# Staff Report

Re: PLNPCM2019-00926 Design Review

## Design Review

**PROPERTY ADDRESS:** 255 S State Street

DRAWING NO: US-3610r1

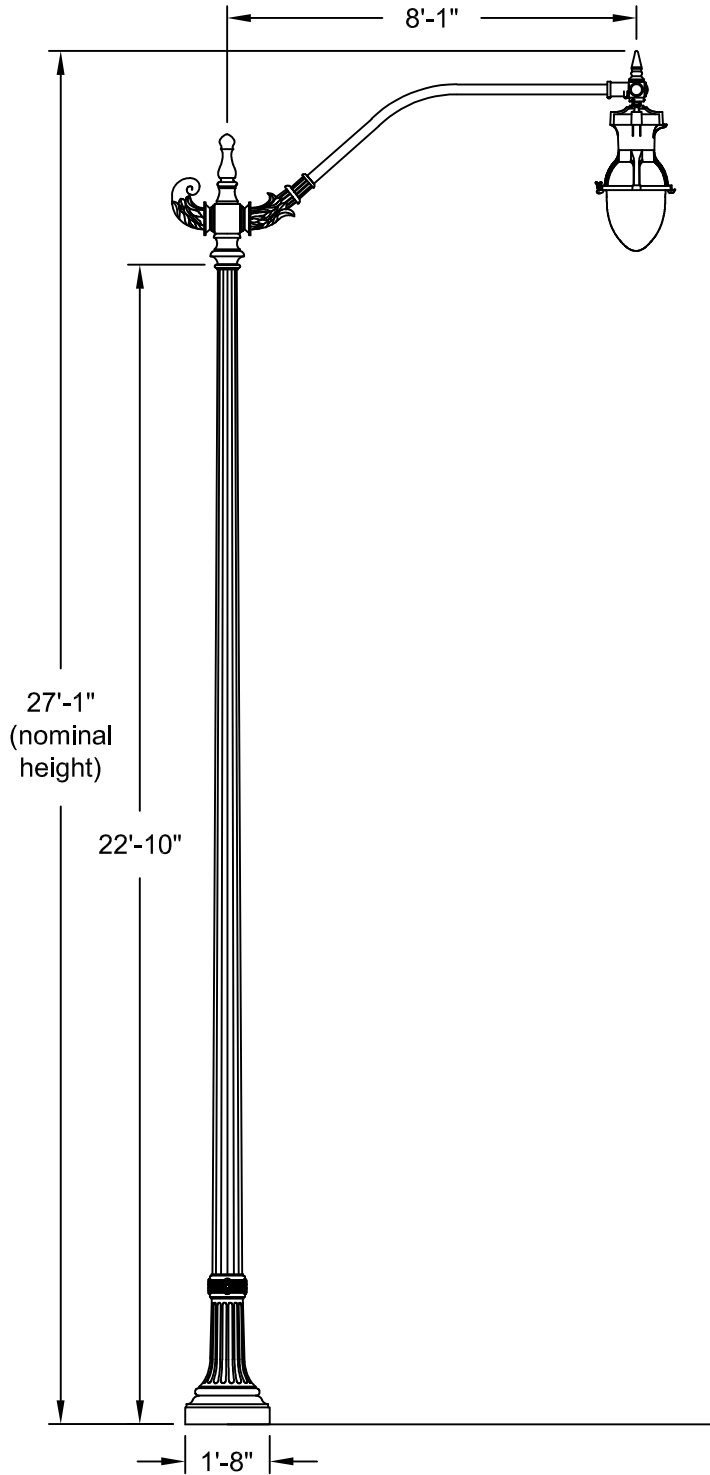
Installation of “Tear Drop” along State Street will be required (see attached spec sheet). Spacing should be about 100’ to 110’ but keeping with the spacing of the existing lights. If new lights are placed somewhere near where the old ones were that spacing would likely be appropriate.
